**RE: SUPPLEMENTARY FLOOD ASSESSMENT IN RESPONSE TO SHOALHAVEN CITY COUNCIL REQUEST FOR FURTHER INFORMATION – PROPOSED EXPANSION OF SAND EXTRACTION AT PIG ISLAND, TERARA, NSW**

Martens and Associates (**MA**) have prepared this response on behalf of Terara Shoalhaven Sand (the **Proponent**) to address the flood related items in the Request for Further Information (**RFI**) from Shoalhaven City Council (**Council**, dated 19 April 2022, REF: RA21/1000) in relation to a proposed expansion of sand extraction at Pig Island, Terara, NSW (the **Site**).

0 100 200 300 400 500 m

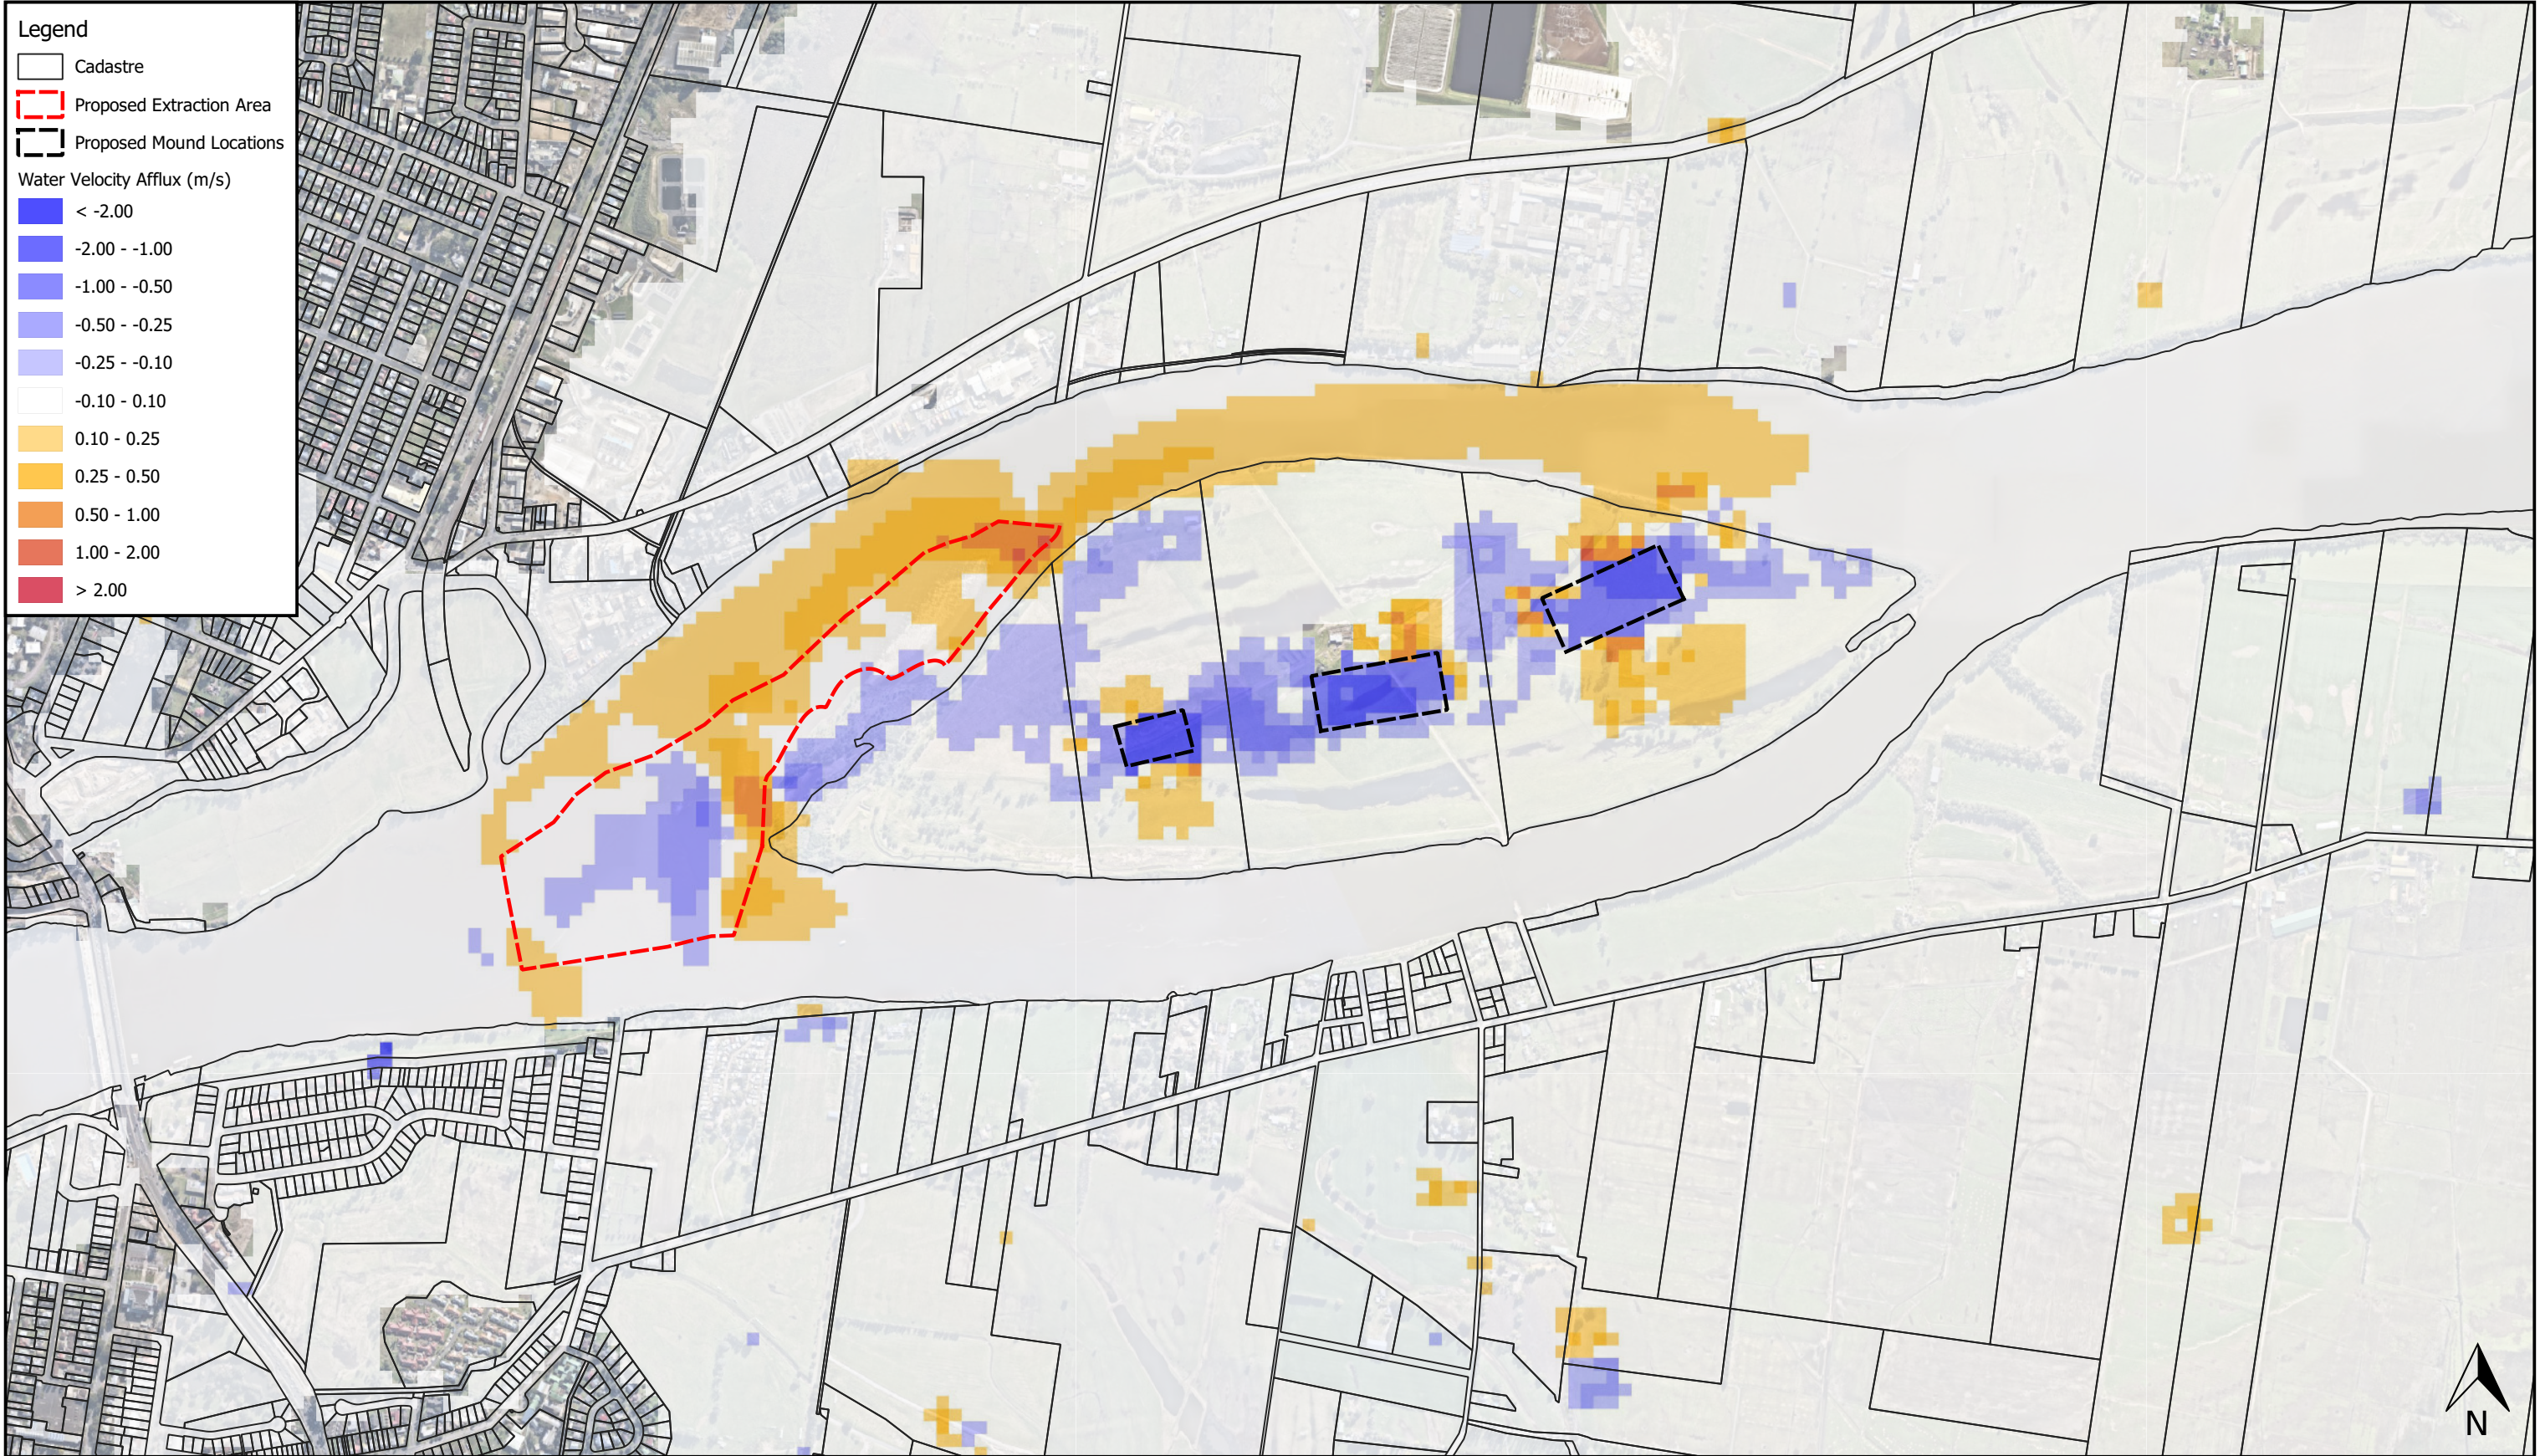
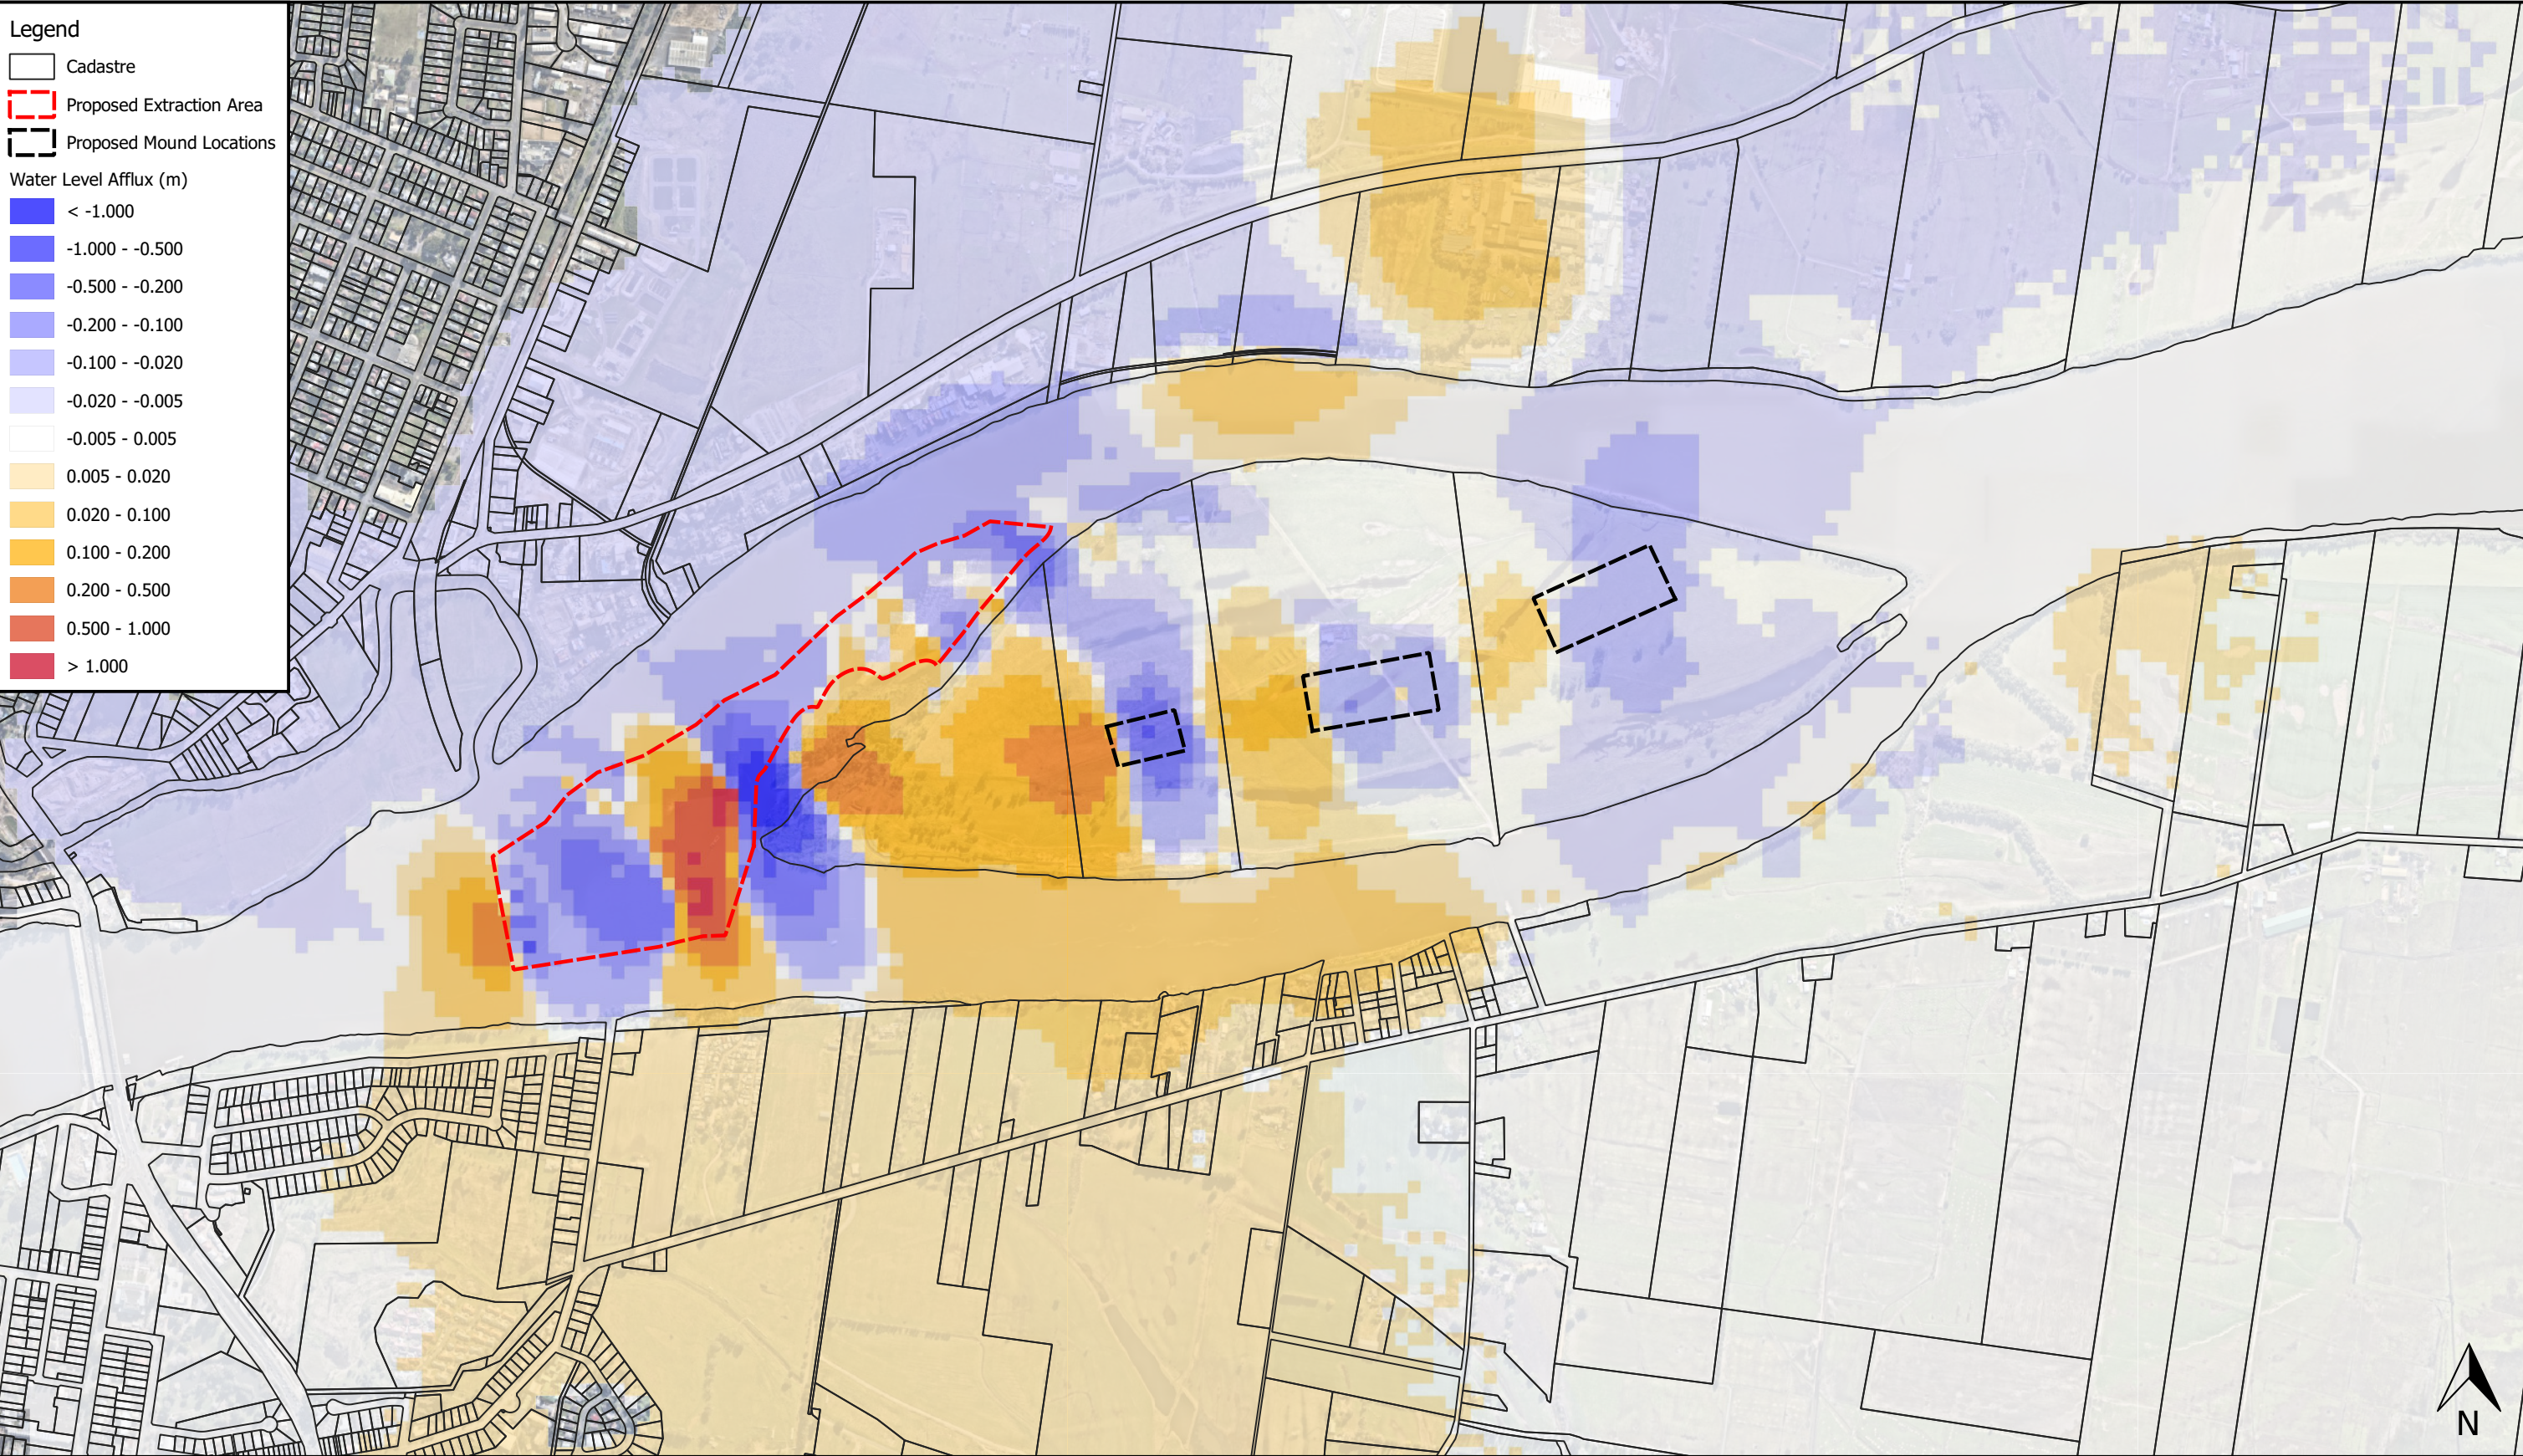
<p>h) <i>The report identifies that the expanded dredge area would result in negligible changes to flood velocities, hazard and hydraulic categories. It is however noted that no velocity difference maps have been provided. Velocity difference maps are required for the full range of flood events modelled.</i></p>	<p>(8) See Attachment A Map FL02, Map FL04, Map FL06, Map FL08 &amp; Map FL10 for the full range of velocity afflux maps.</p>
